SERVICE BULLETIN

ENGINE COOLING IMPROVEMENT

Boeing 600N helicopters, serial numbers RN003 thru RN017.

Engine Oil System Installation (P/N 369D28300-509).

Figure 1. Engine Cooling Improvement Modification

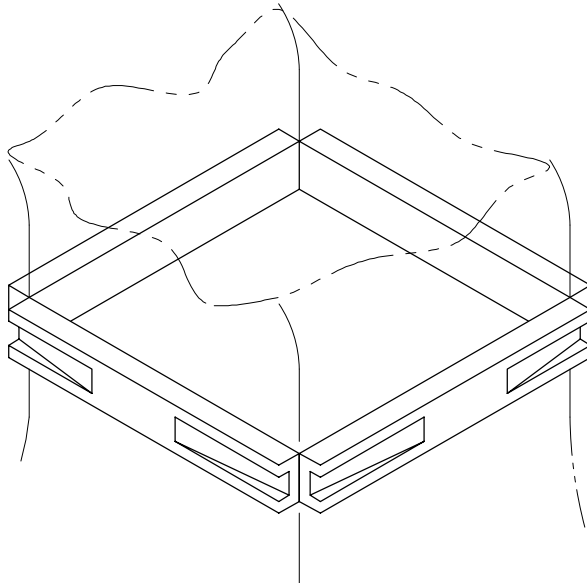
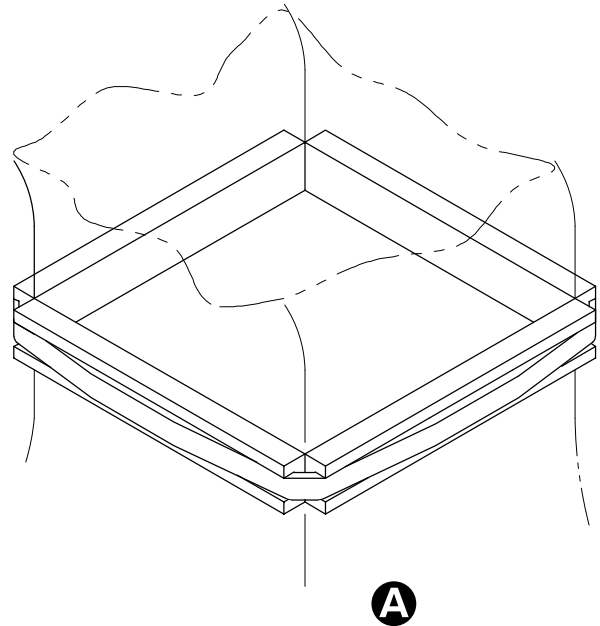
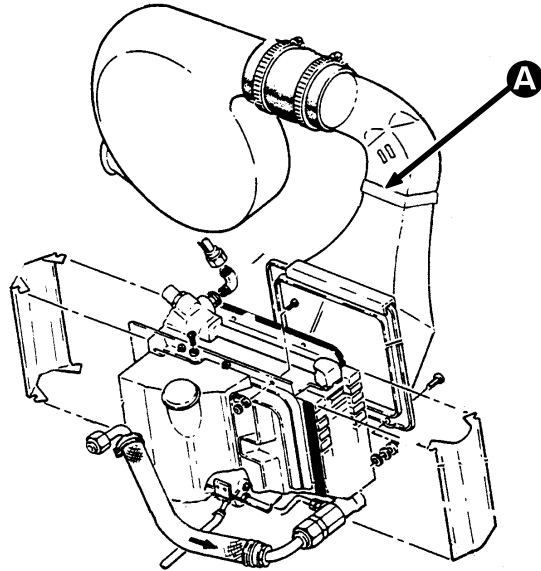
To improve engine oil cooling allowing an increase in the ambient temperature operating environment to 125°F at sea level. Compliance with the requirements of this Bulletin shall increase the allowable operating temperature environment (refer to Rotorcraft Flight Manual, CSP-600RFM-1, Revision 3 or later. See Section II, Figure 2-1 Ambient Temperature Envelope). Accomplishing the requirements of this Bulletin makes the oil cooler duct installation equivalent to a 369D28300-511 installation.

Procedures in this Bulletin provide owners and operators with information pertaining to installing eight (8) stiffeners around the oil cooler ducting installation held in place by ty-straps.

- (1). Remove interior and stress panels, as required, to gain access to the engine oil cooling duct area.
- (2). Remove the two MS3367-6-9 ty-straps that hold the 369D28303 engine oil cooler duct connector in place.
- (3). Refer to Figure 1. Install four 600N8301-1 oil cooler duct seal stiffeners underneath each of the ty-straps (one on each of the four sides, two places) and tighten ty-straps.
